**Subject: LaChausse Dam – Inventory Number TX03755
Tyler County, Texas**

Dam Safety Inspection Report

LaChausse Dam – TX03755

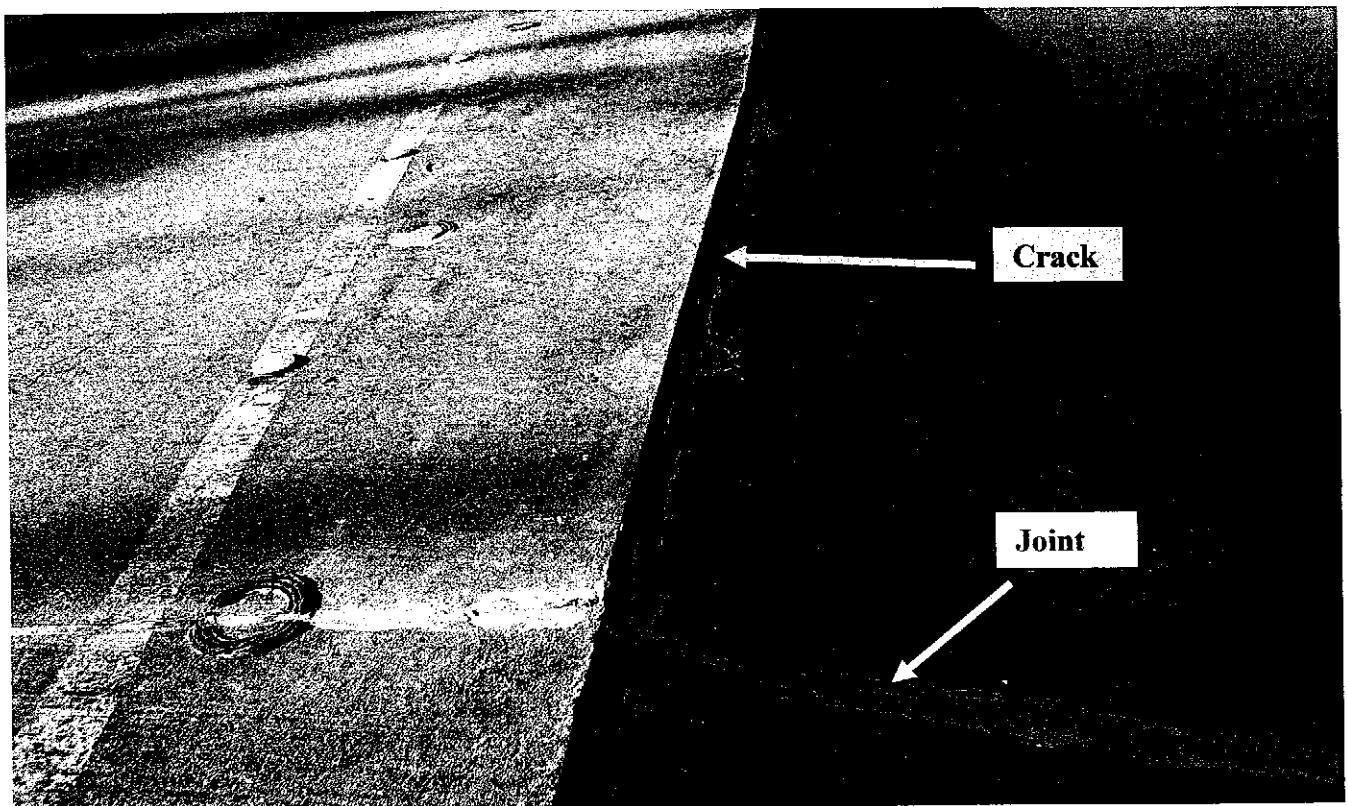
Photo 3. Upstream slope. View is looking south from the left end of the dam. An open joint was present between the dam crest and upstream slope along the entire length of the embankment. Additionally, the sealant in the joints between the concrete panels on the slope was deteriorated.

Photo 4. Upstream slope. View is of the open joint between the dam crest and upstream slope. The joint was a maximum of approximately 2.5 inches wide and 4.5 inches deep. Also a small crack with no displacement was present in the concrete panel.

Photo 7. Upstream slope. View is of cracks in the upstream slope's concrete cover

Photo 8. Upstream slope. View is of a joint between concrete panels on the upstream slope. The elastic sealant in the joint was deteriorated and vegetation was growing in the joint.

Photo 11. Downstream slope/Stilling basin. View is of one of several active sand boils located in the stilling basin near the right end of the downstream slope.

Photo 12. Downstream slope/Stilling basin. View is of two sand boils located in the stilling basin near the right end of the downstream slope

3. As recommended in the 2004 and 2007 inspection reports, the interface between the upstream slope pavement and the dam crest needs to be repaired. A Texas licensed professional engineer should inspect the interface and develop plans for repair. Any plans for repair of this area must be approved by TCEQ Dam Safety Section staff prior to initiating the repairs and be implemented under the supervision of your Texas licensed professional engineer.

4. As recommended in the 2004 and 2007 inspection reports, all joints and cracks in the embankment's concrete cap should be cleaned and resealed with an appropriate elastic sealant.

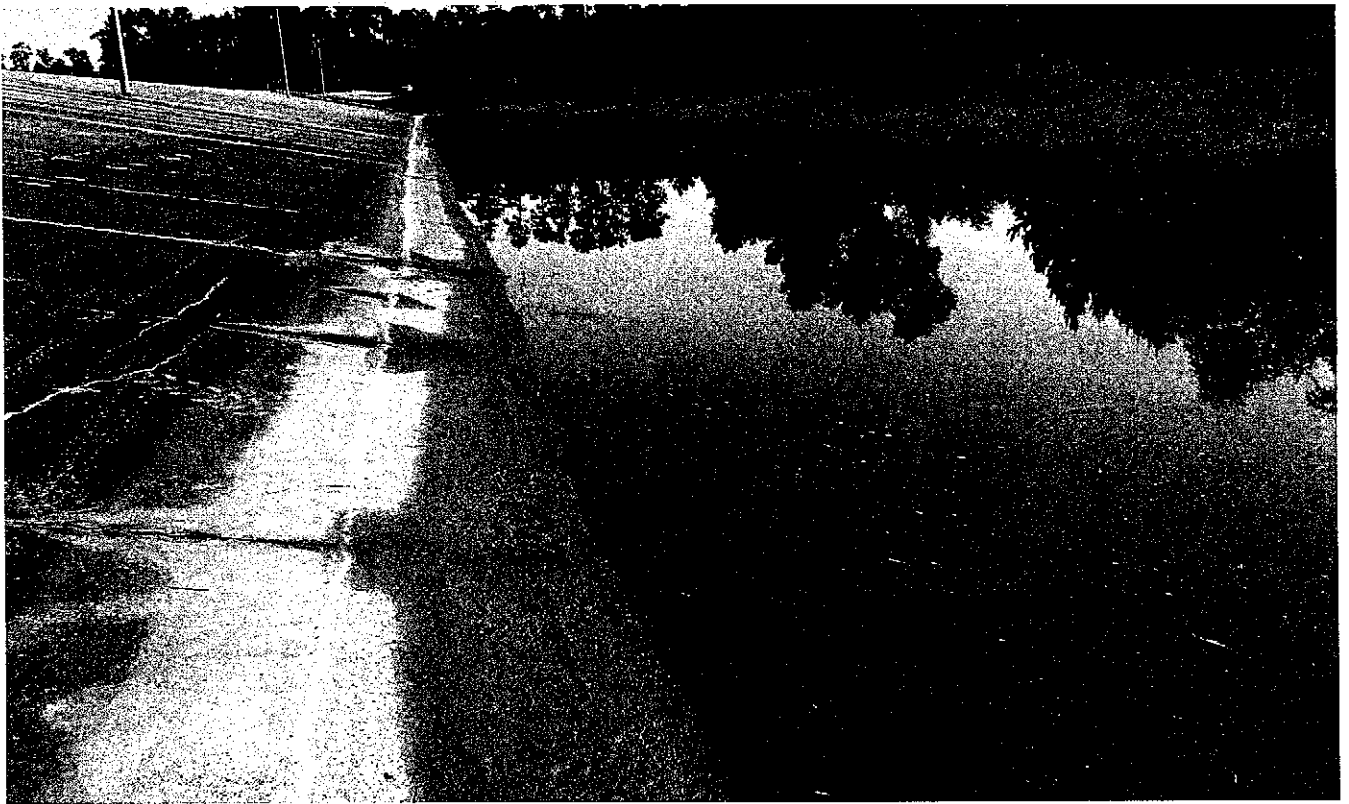
Photo 15. Downstream slope/Stilling basin. View is looking north from near the right end of the downstream slope. The slope was relatively uniform in grade. Seepage was present along some joints. The utility poles present on the upper portion of the slope were vertical and showed no signs of slope movement.

Photo 16. Downstream slope. View is of a sediment filled weep hole near the right end of the downstream slope.

5. All joints and cracks in the principal spillway's concrete cap should be cleaned and resealed with an appropriate elastic sealant.
6. As recommended in the 2004 and 2007 inspection reports, weep holes should be cleared of sediment and vegetation.

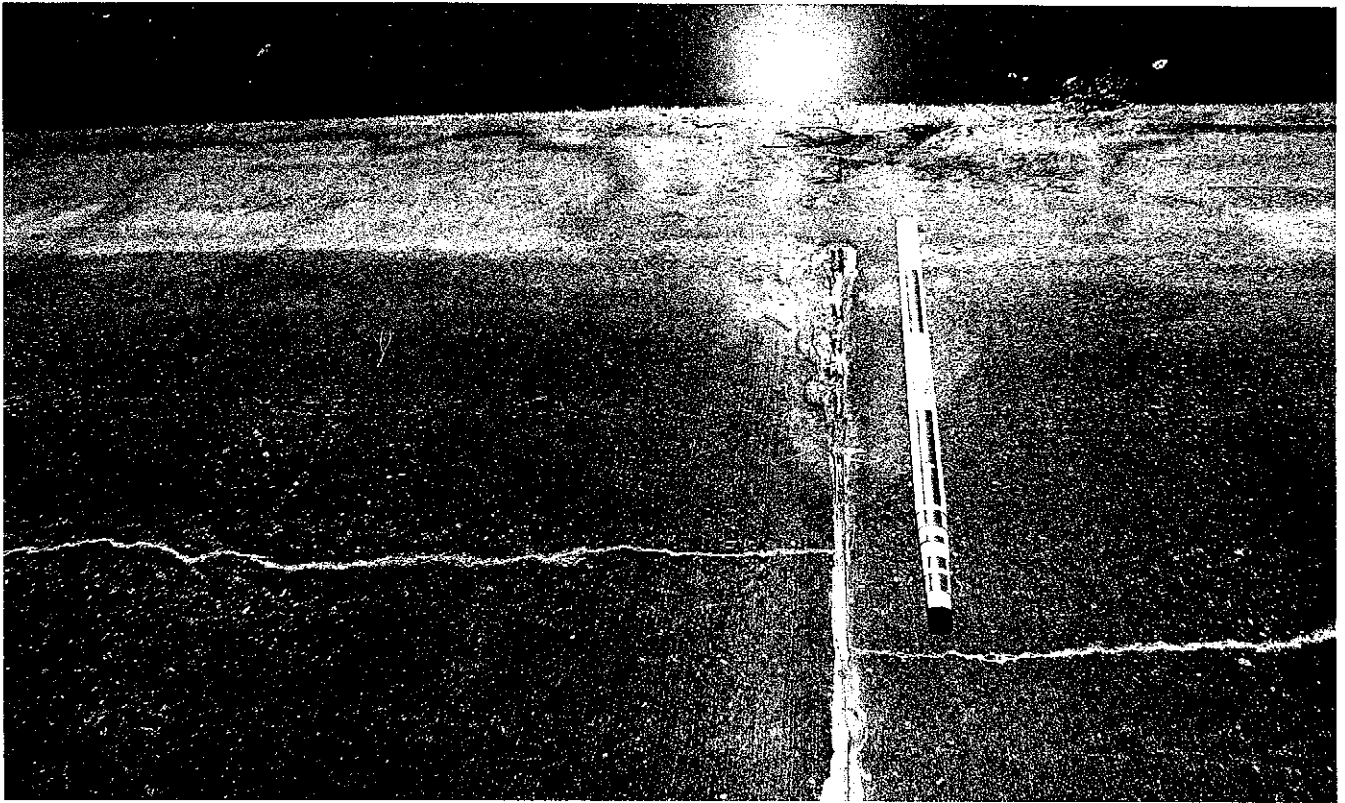
Photo 19. Downstream slope. View is of seepage from a joint on the downstream slope. Note that the seepage was emanating from a point several feet above the downstream toe of the embankment. Longitudinal cracks were present in the embankment's concrete cover.

Photo 20. Downstream slope/Stilling basin. View is of longitudinal cracks in the concrete cover and sediment and vegetation in the joints between concrete panels. Sediment was also present in the stilling basin.

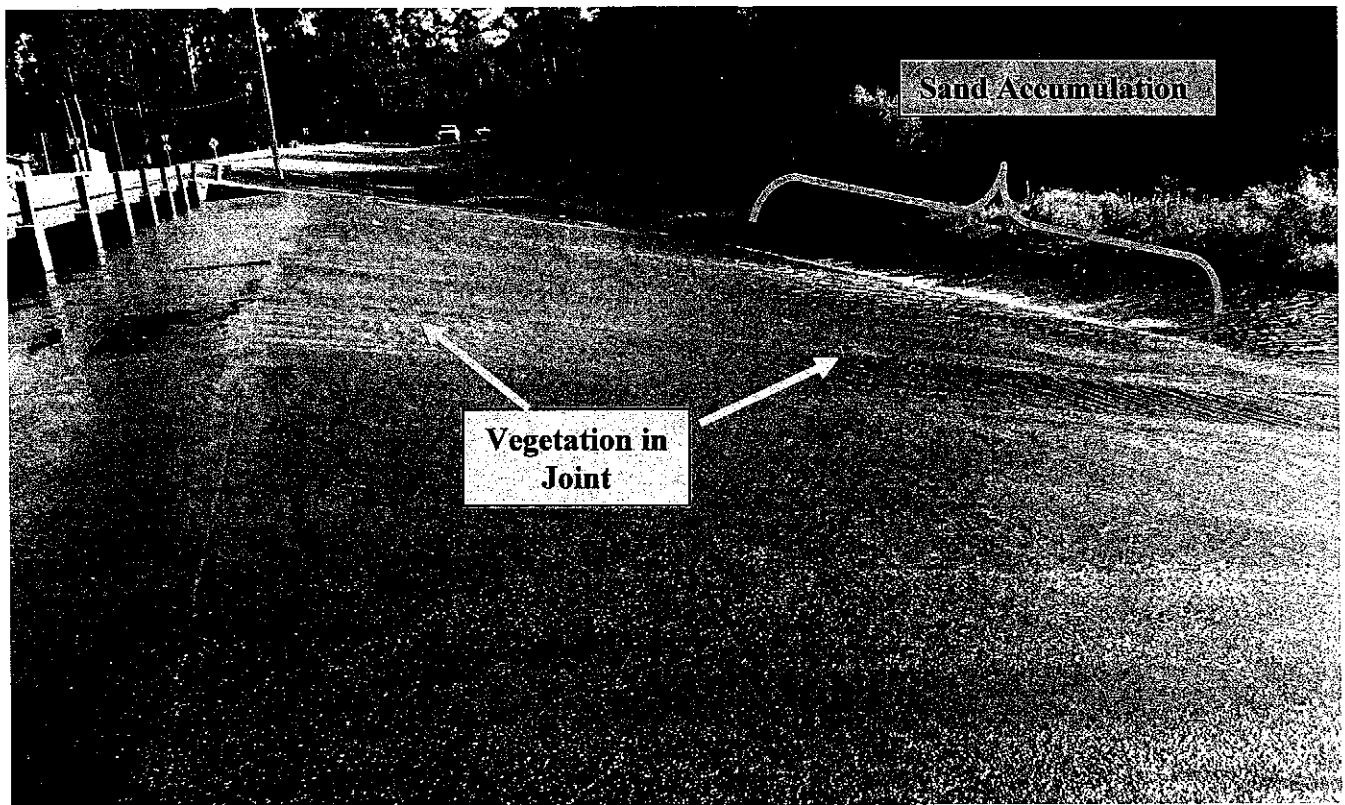
Photo 23. Principal spillway. View is looking north across the downstream side of the principal spillway. The spillway was engaged. Vegetation was growing in the joint where noted. Note the areas of accumulated sand along the downstream toe.

Photo 24. Principal Spillway. View is of a joint with vegetation on the spillway discharge area. Note the areas of accumulated sand along the downstream toe.

Photo 27. Principal Spillway. View is of cracked and spalled concrete at the base of a guardrail post secured to the bridge over the principal spillway. This photo is representative of the condition of many other guardrail posts on the bridge.

Photo 28. Principal Spillway. View is of a possible boil located beneath a loose metal plate near the downstream toe of the principal spillway discharge chute.

7. As recommended in the 2004 and 2007 inspection reports, spalling and cracks in the concrete at the base of guard rail posts should be repaired.
8. As noted in the 2004 and 2007 inspection reports, a Texas licensed professional engineer should evaluate and develop plans for repair of the cracked and spalled concrete in the principal spillway's right sidewall.
